Proposed Amendments to the Alta Vista – Faircrest Heights – Riverview Park Secondary Plan

Schedule 1

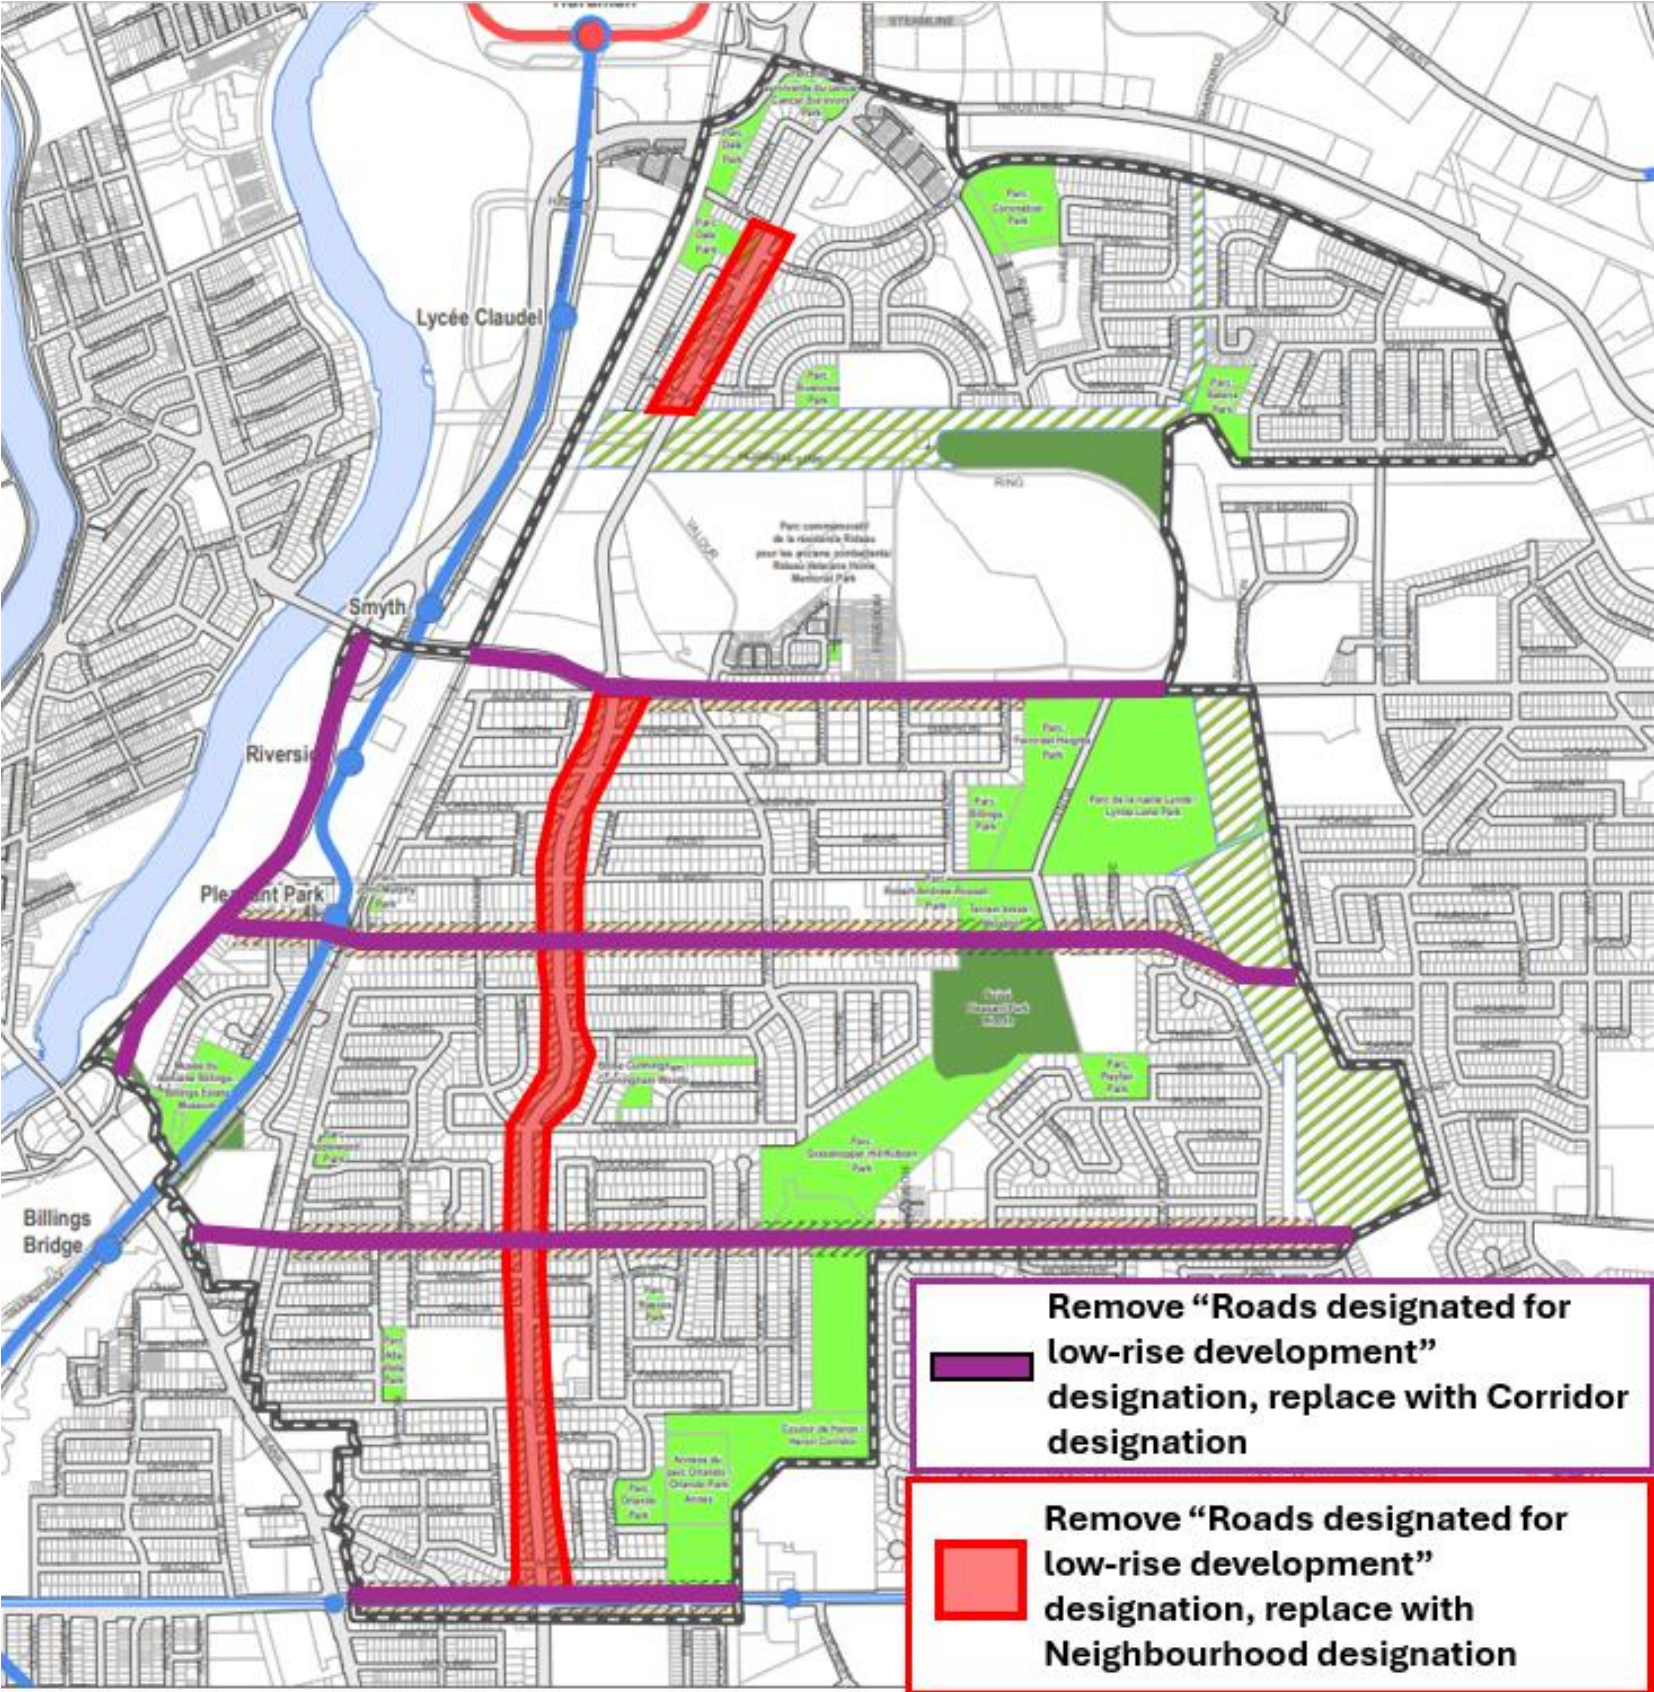
<p><u>c) For sites generally of greater than one hectare in area or 100 metres in depth:</u></p> <p><u>i) Shall be required to establish an enhanced circulation network throughout the site that prioritizes the needs of pedestrians, cyclists and transit users; and</u></p> <p><u>ii) Where development is proposed to occur in phases, may be required to build phases closest to the Corridor before phases located at the back of the site, subject to any overlay that may apply; and</u></p> <p><u>d) Shall be prohibited from including functions or uses causing or likely to cause nuisance due to noise, odour, dust, fumes, vibration, radiation, glare or high levels of heavy truck traffic.</u></p> <p><u>4) Corridors will generally permit residential uses and such non-residential uses that integrate with a dense, mixed-use urban environment. The City may require through the Zoning By-law and/or development applications to amend the Zoning By-law:</u></p> <p><u>a) Commercial and service uses on the ground floor of otherwise residential, office and institutional buildings with a strong emphasis on uses needed to contribute to 15-minute neighbourhoods;</u></p> <p><u>b) Residential and/or office uses on the upper floors of otherwise commercial buildings; and/or</u></p> <p><u>c) Minimum building heights in terms of number of storeys to ensure multi-storey structures where uses can be mixed vertically within the building.</u></p> <p><u>5) Along Corridors, permitted building heights, subject to appropriate height transitions and stepbacks shall not be less than 2 storeys and up to 6 storeys.</u></p> <p><i>Renumber subsequent policies.</i></p> <p><u>11) Building heights up to 27 storeys are permitted at 1245 Kilborn Avenue, provided there is an appropriate transition to any abutting low-rise areas.</u></p> <p><i>Schedule A – Designation Plan is amended by deleting the “Roads designated for Low-Rise Neighbourhood development” designation and adding the “Corridor” designation as shown below on Schedule 1.</i></p>

~~Roads designated for Low-Rise Neighbourhood development / Routes désignées pour les usages locaux de faible hauteur~~
